RE: *Initial Submission Review – Economy Rental Parking Expansion - Site Plan Amendment and Plat*
Application Number: DA-2113-01
Case Numbers: 2017-6049-02; 2023-3018-00

ECONOMY RENTAL PARKING EXPANSION
 AT PORTEOS - PARCEL B
 SITE PLAN
 CITY OF AURORA
 OVERALL SITE PLAN

ECONOMY RENTAL PARKING EXPANSION AT PORTEOS SUBDIVISION FILING NO. 2

ECONOMY RENTAL PARKING EXPANSION AT PORTEOS - PARCEL B SITE PLAN CITY OF AURORA SITE DETAILS

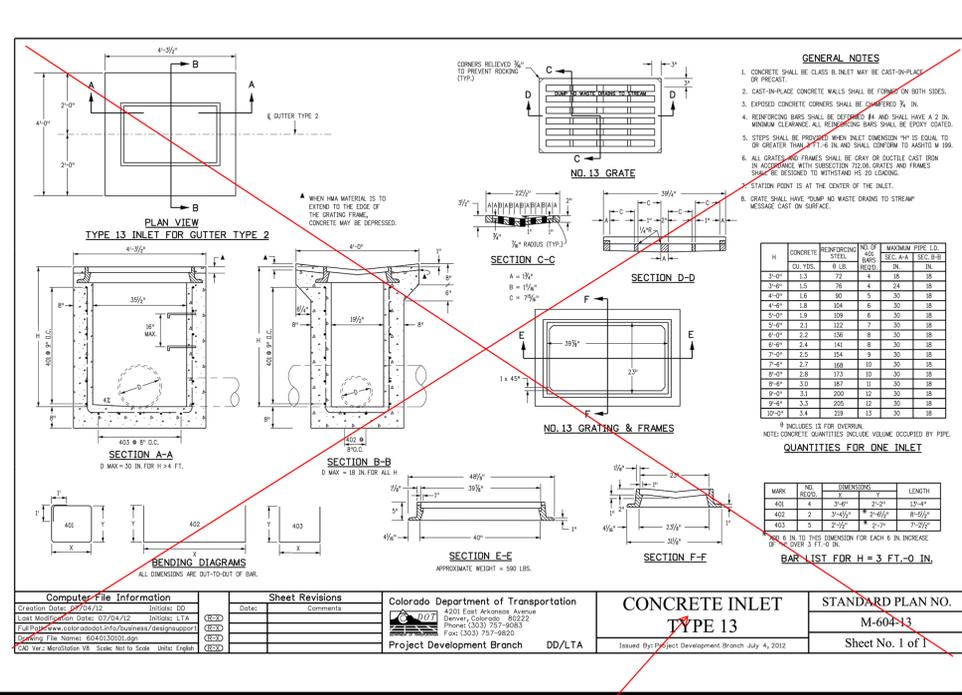
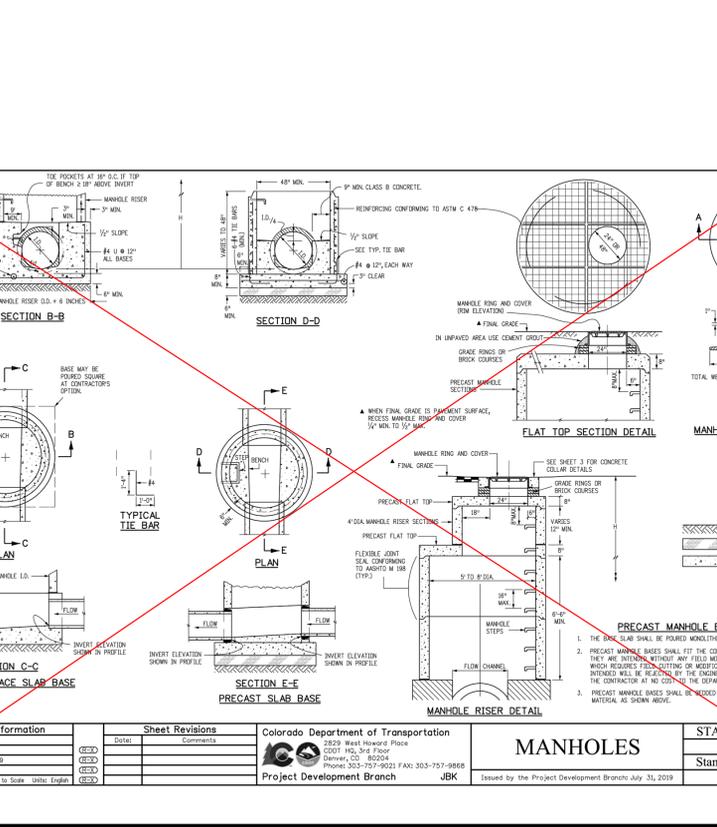
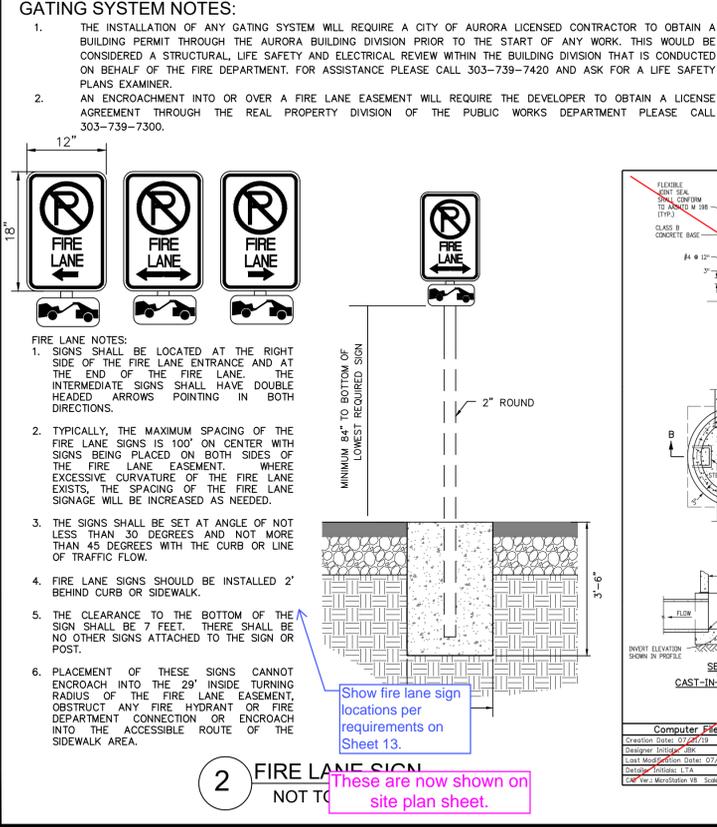
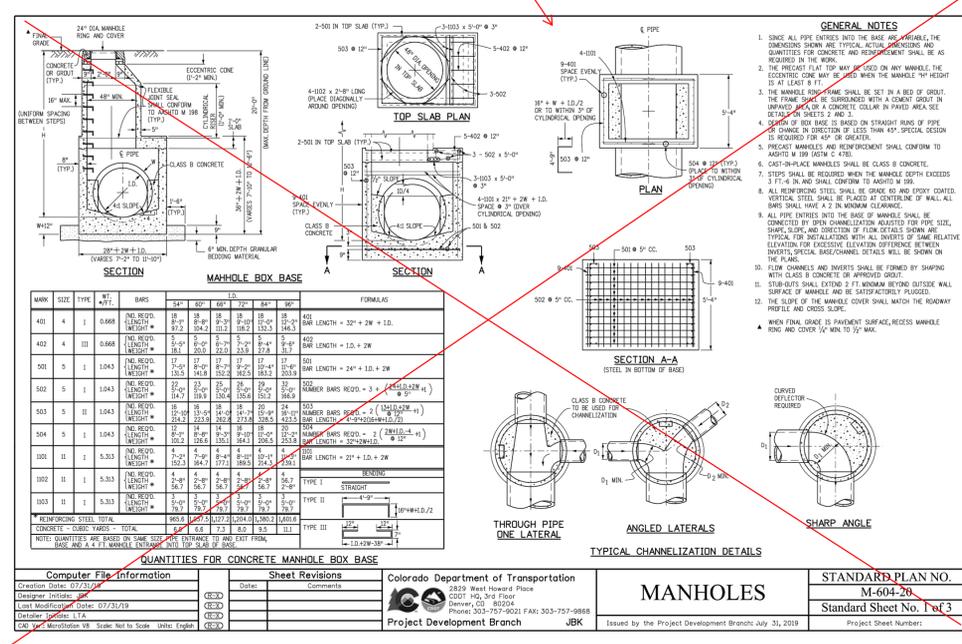
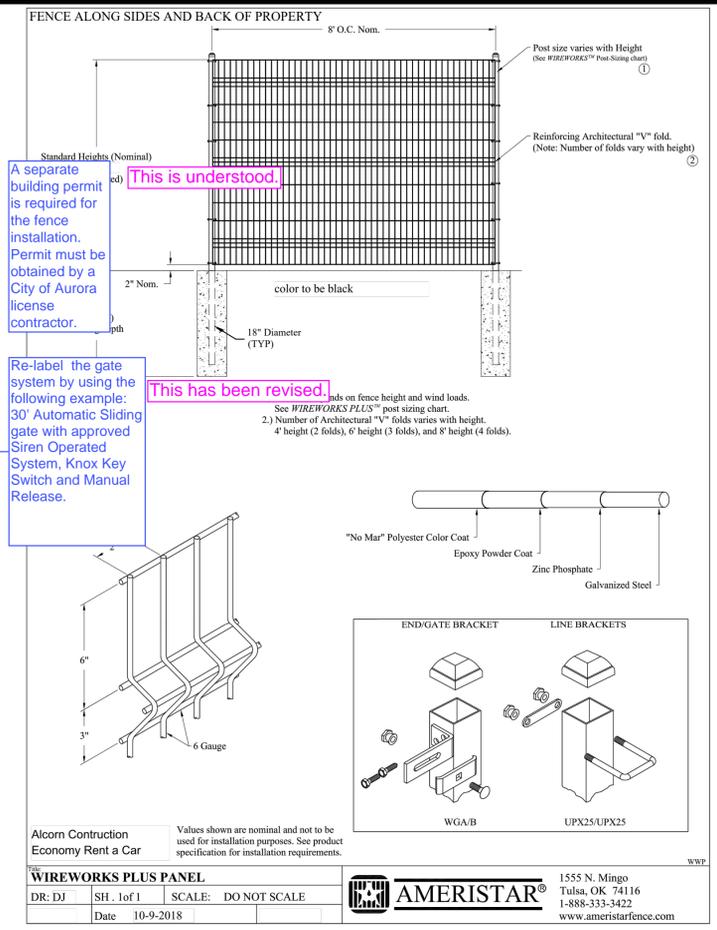
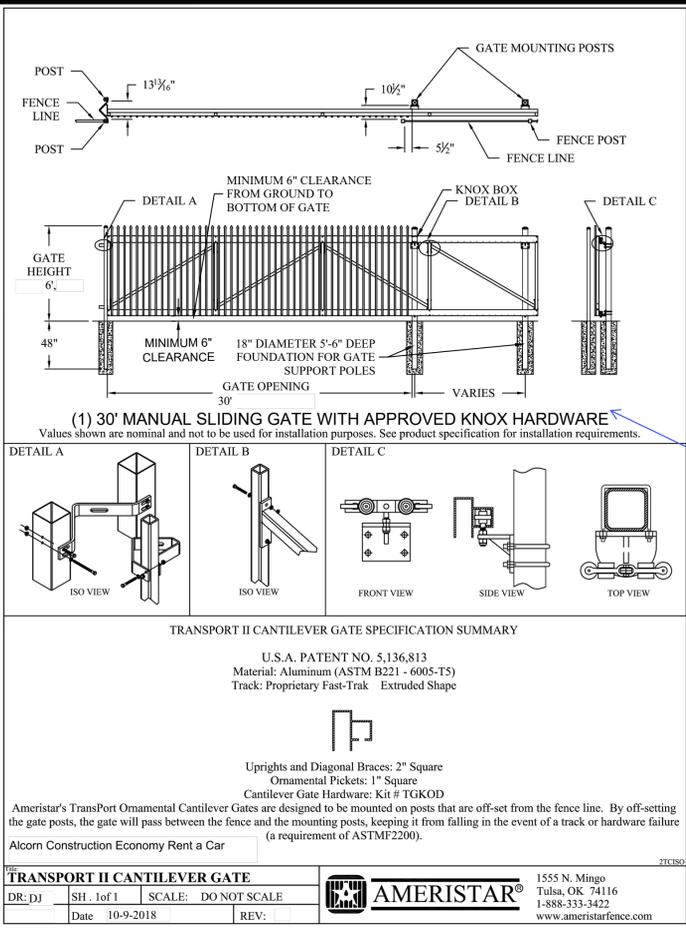
Storm sewer manholes shall conform to the Aurora Water standards and specifications.

CDOT standards can be by reference only.

This is understood.

These have been removed.

FIGURE 2
ACE-RENT-A-CAR (PARCEL B)
AURORA, COLORADO
2023 EXISTING TRAFFIC VOLUMES

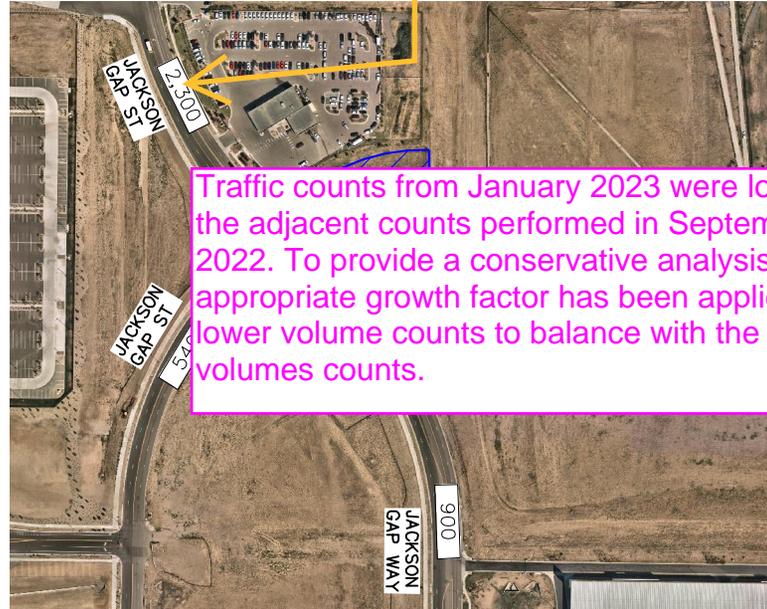
Sept 2022 daily traffic was 3,100 veh,
explain reason for less than 4 month
decrease in your PA-9c TIS

Traffic counts from January 2023 were lower than the adjacent counts performed in September 2022. To provide a conservative analysis, an appropriate growth factor has been applied to the lower volume counts to balance with the higher volumes counts.

Scale	Drawn by	Checked by	Date	Project No.	Sheet No.
1" = 50	MC	DRW	8/10/2022	196412000	2 OF 2

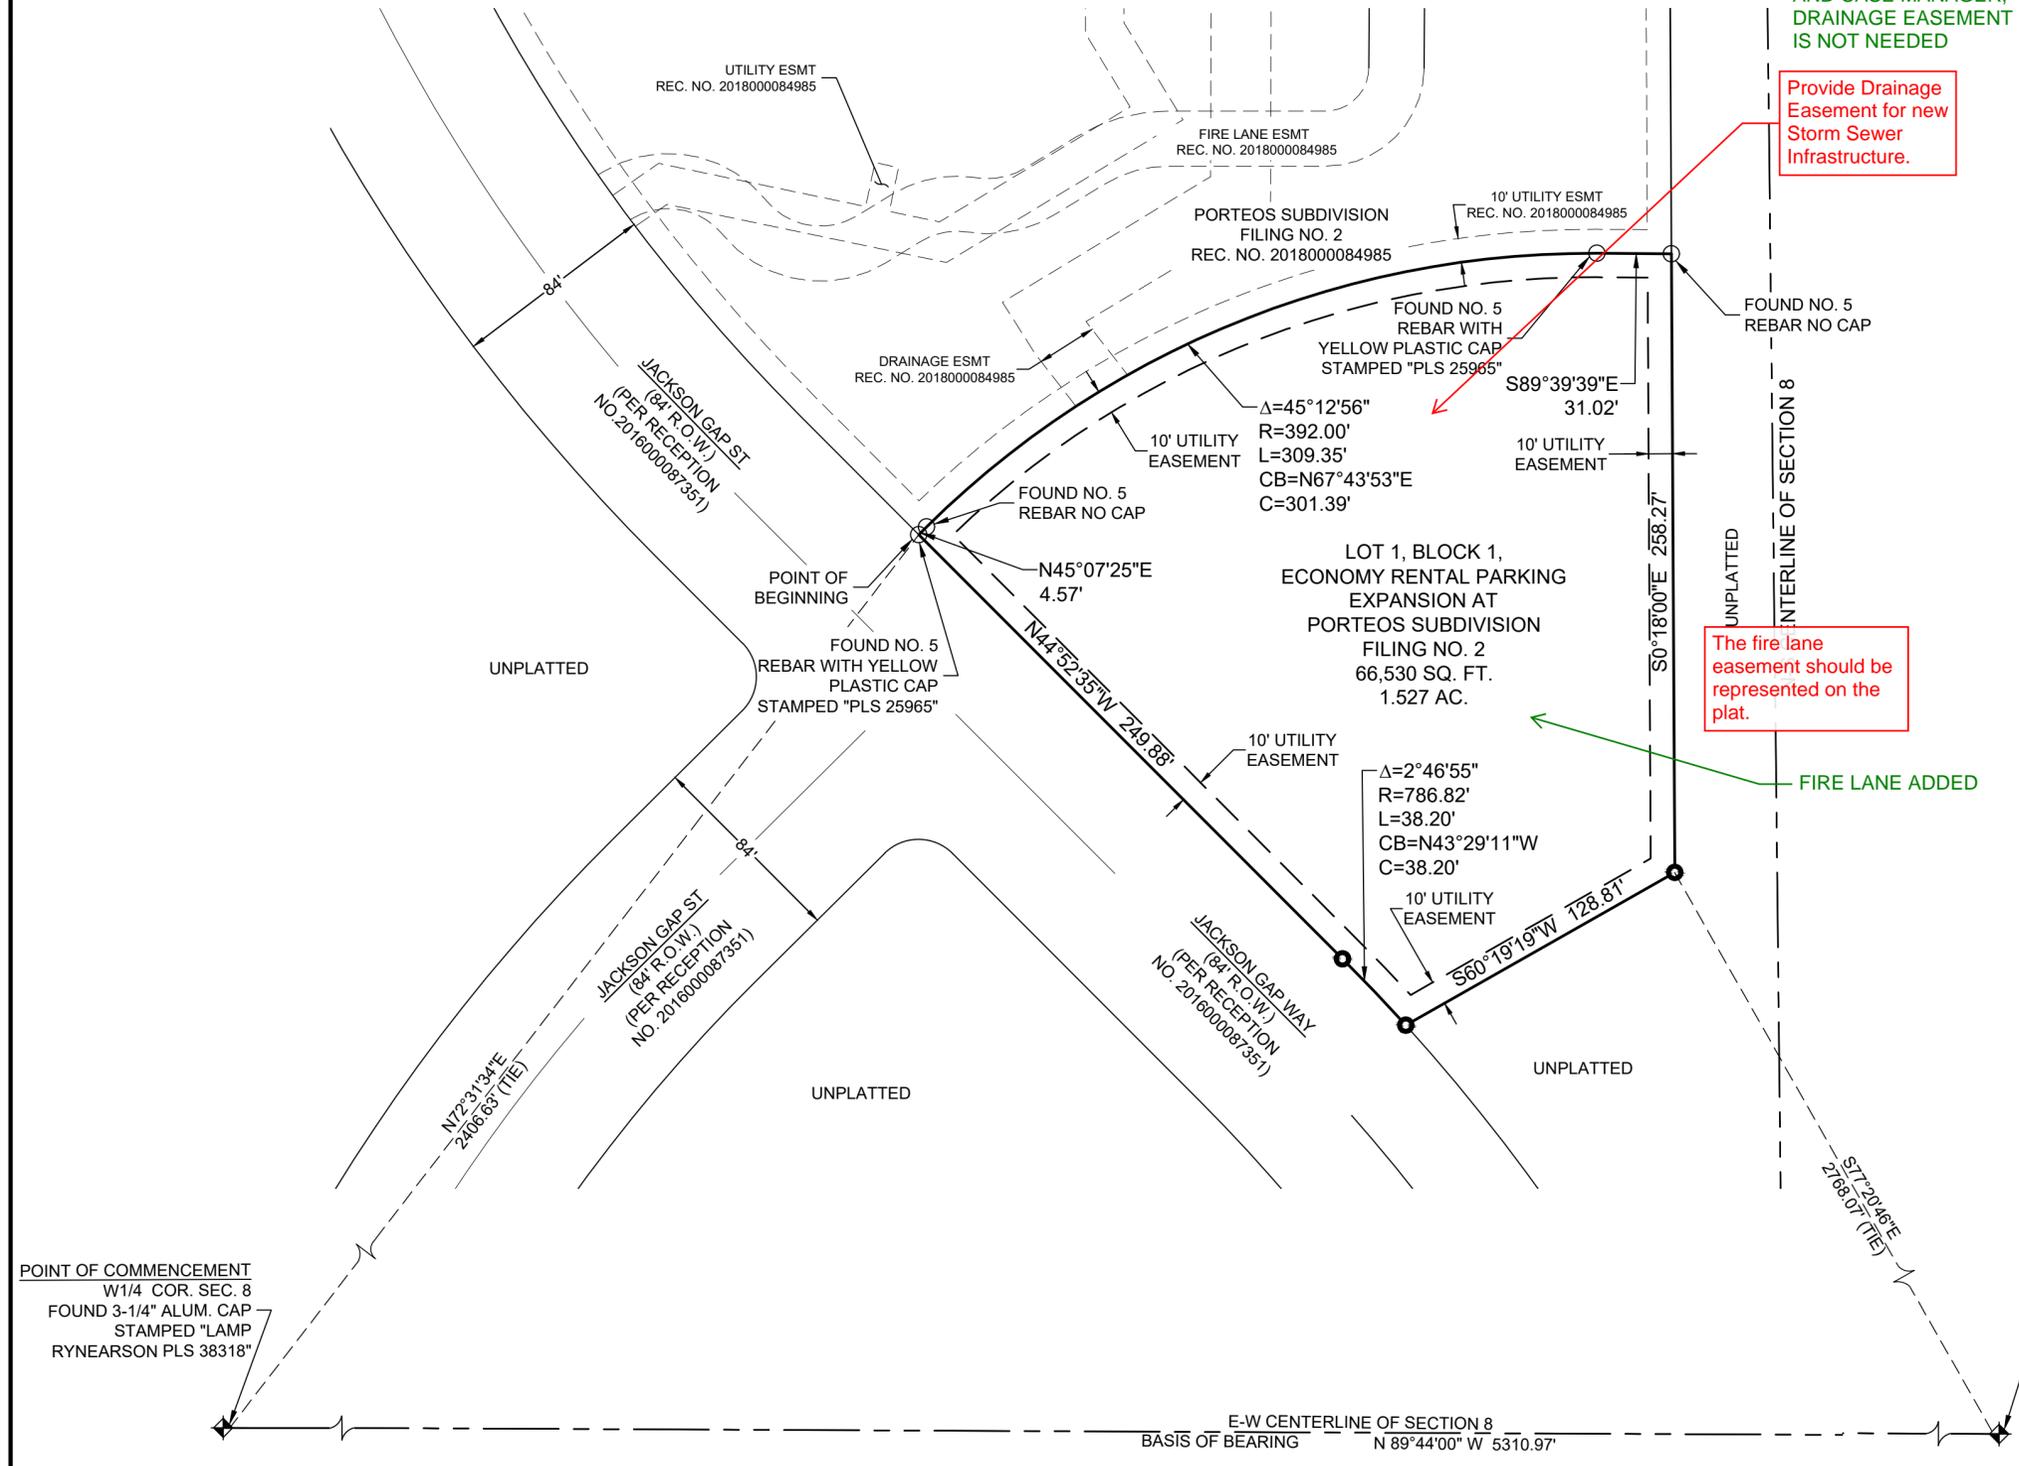
Provide Drainage Easement for new Storm Sewer Infrastructure.

The fire lane easement should be represented on the plat.

FIRE LANE ADDED
